PROPOSED SUBDIVISION CLIPPER TRADERS, LLC

RE: (Subdivision) Site Plan Approval for 105 Bartlett Street; Clipper Traders

We hereby submit, on behalf of Clipper Traders, the attached for consideration at your October 2, 2018 TAC Committee Meeting. The following plan changes / additional submission items are included in response to the comments received at your July 3, 2018 TAC Meeting:

**ROADWAY
PLAN & PROFILE**

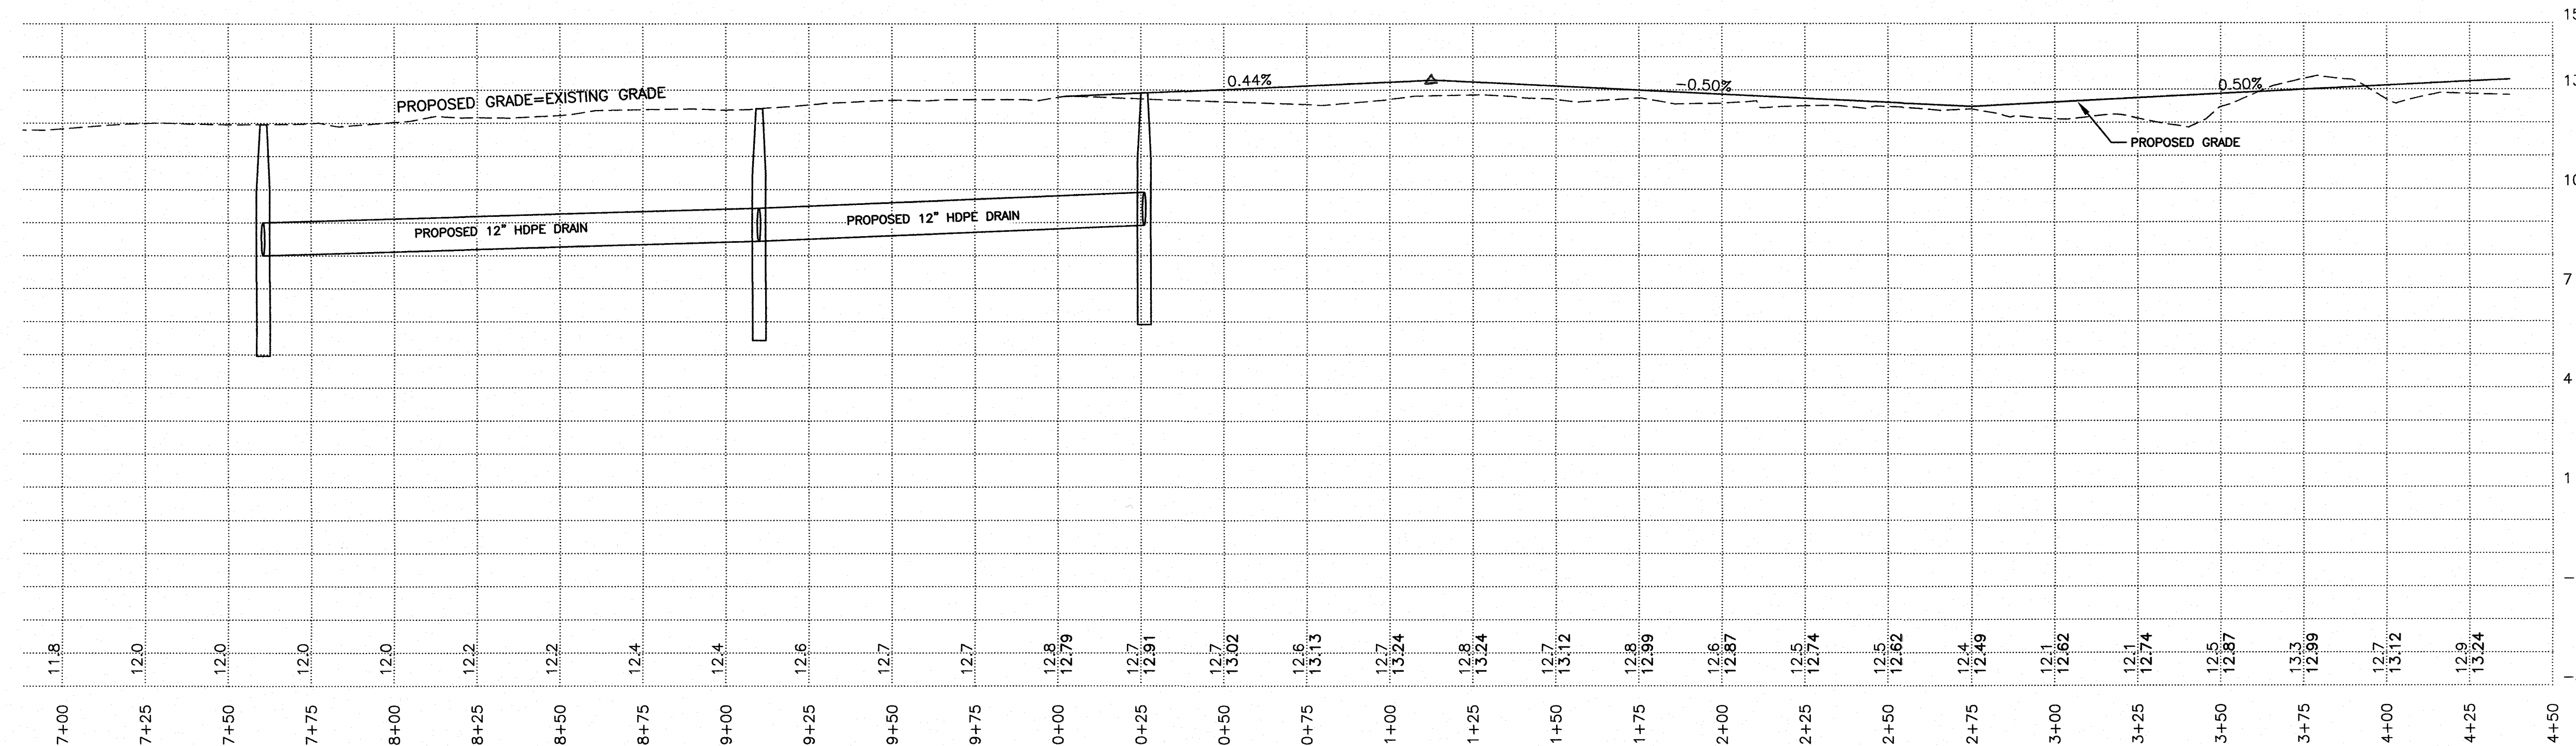
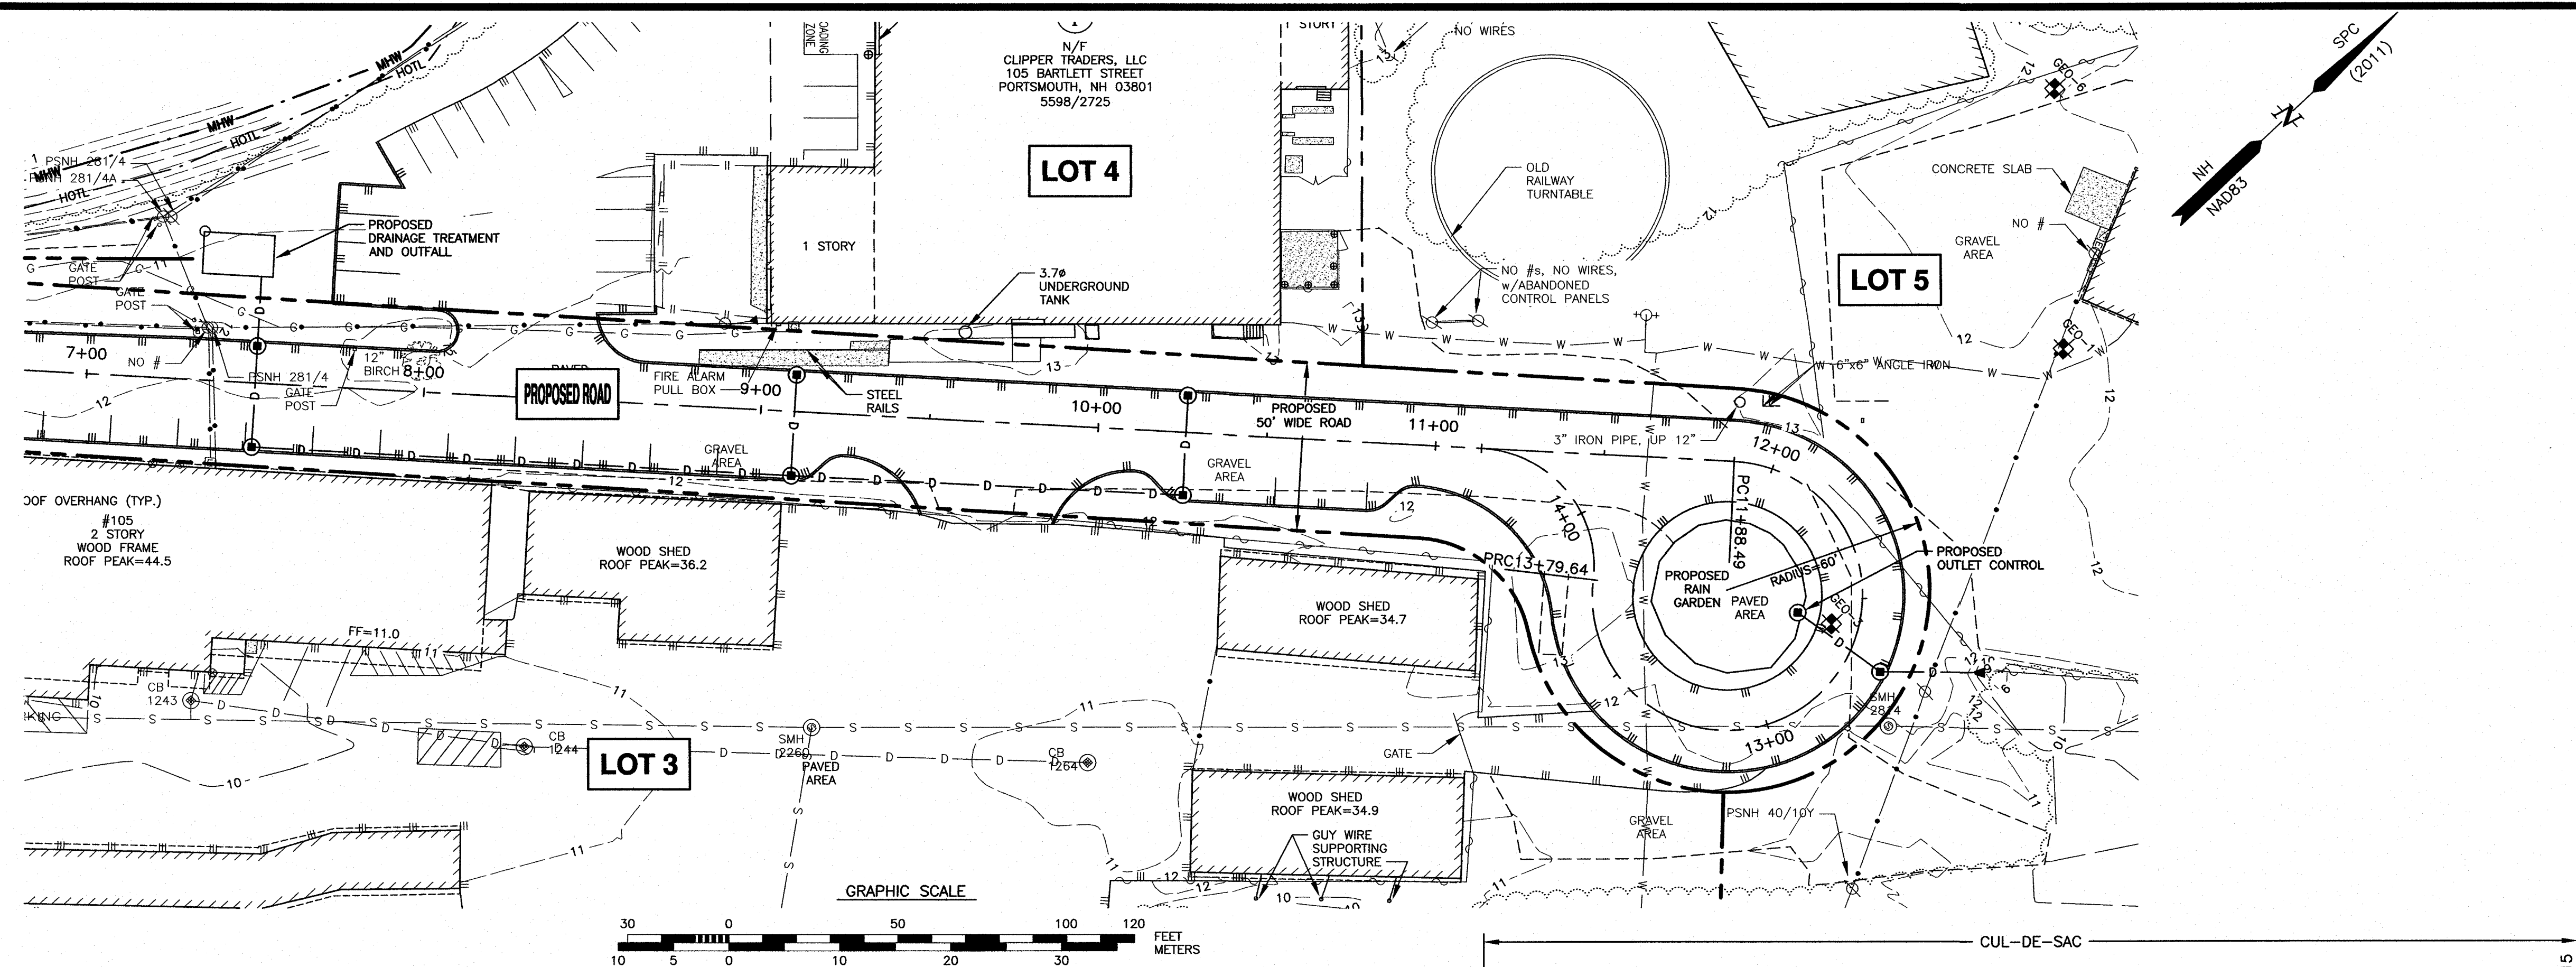
- Roadway Profiles are included. The proposal is to keep the existing pavement except in the area of the cul-de-sac, as shown.
- The approved list of Variances have been added to the plan set.

- 1) THE PURPOSE OF THIS PLAN IS TO SHOW THE PORTSMOUTH INFERNO TURN TEMPLATE AT THE CUL-DE-SAC.

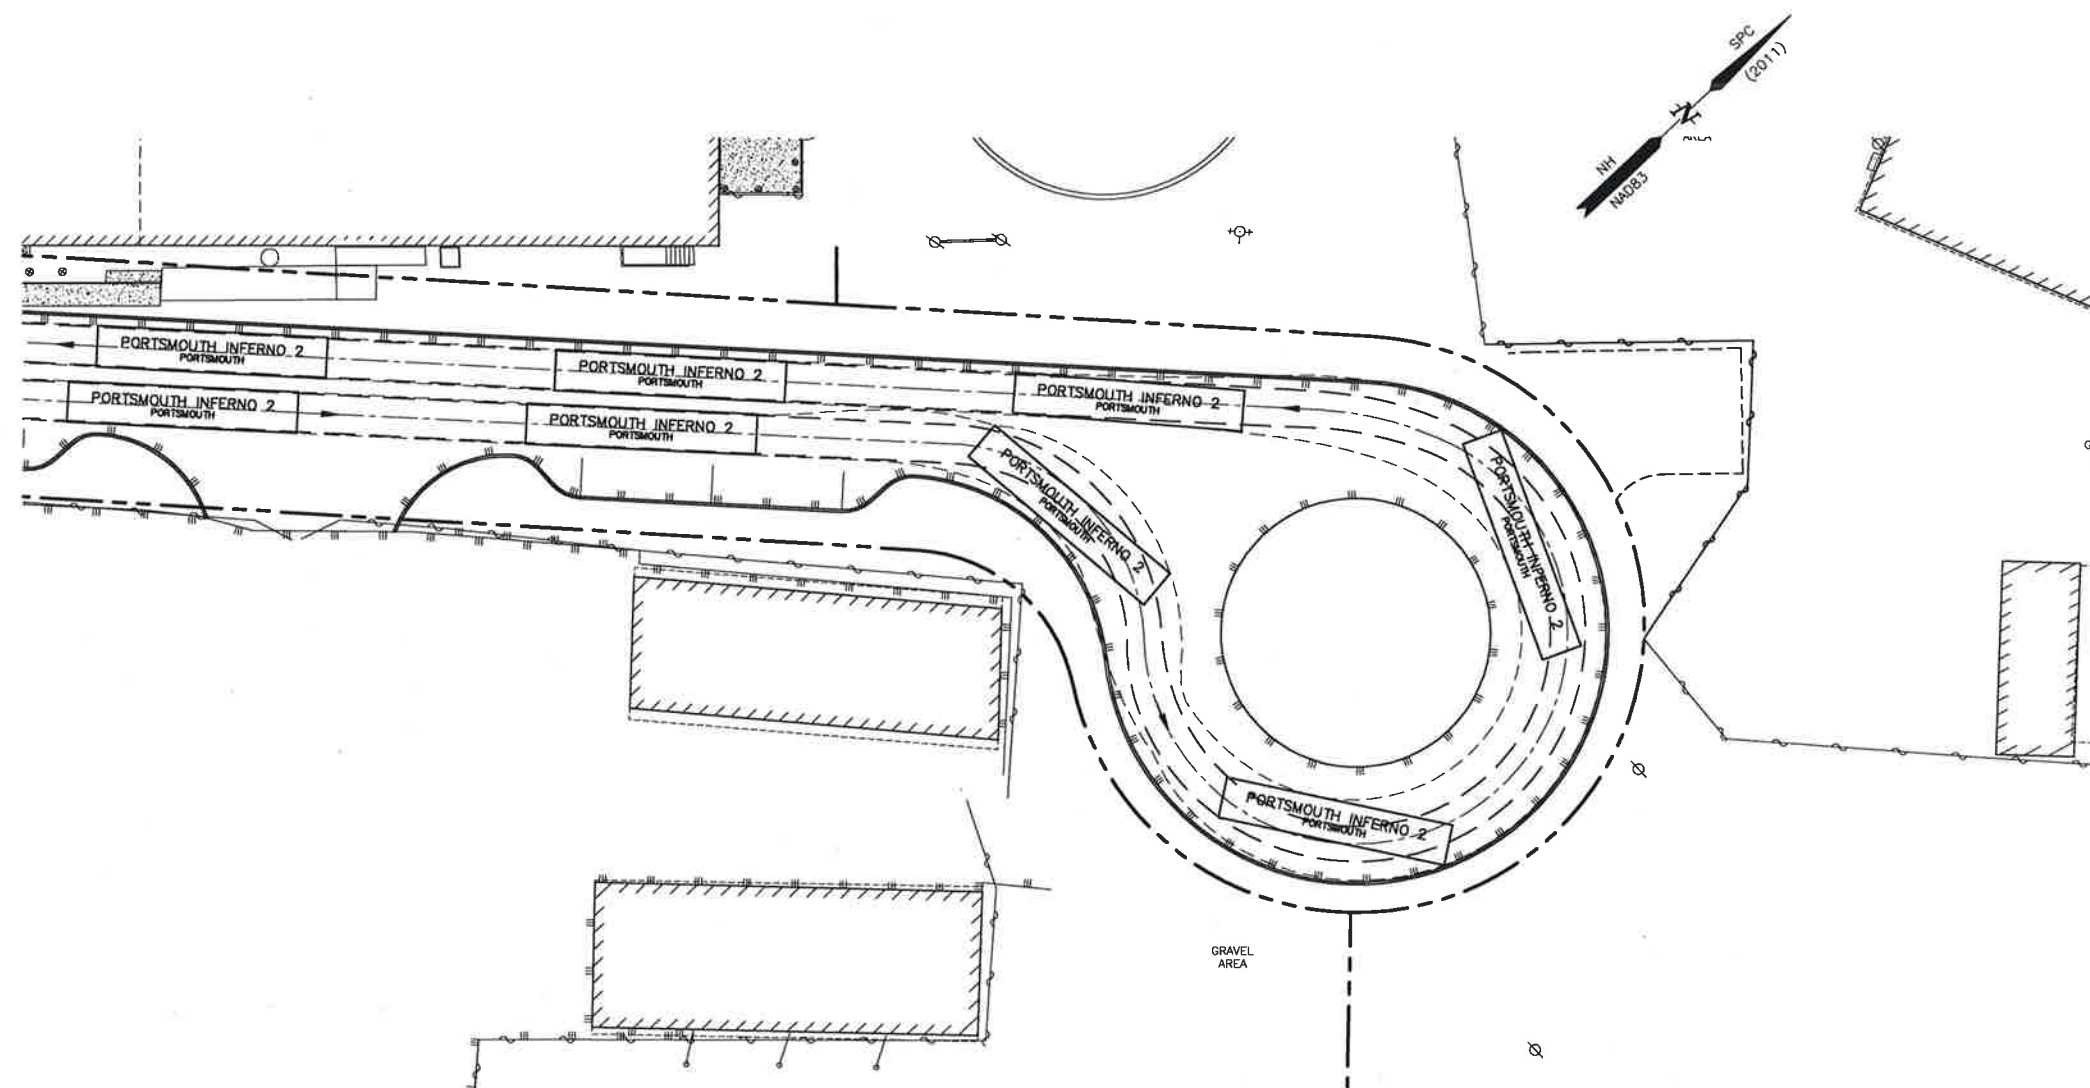
- Waiver requests to the appropriate Portsmouth Road standards are included in a separate letter.
- An exhibit showing that the cul-de-sac allows for the Portsmouth Inferno Fire Truck to turn is included.
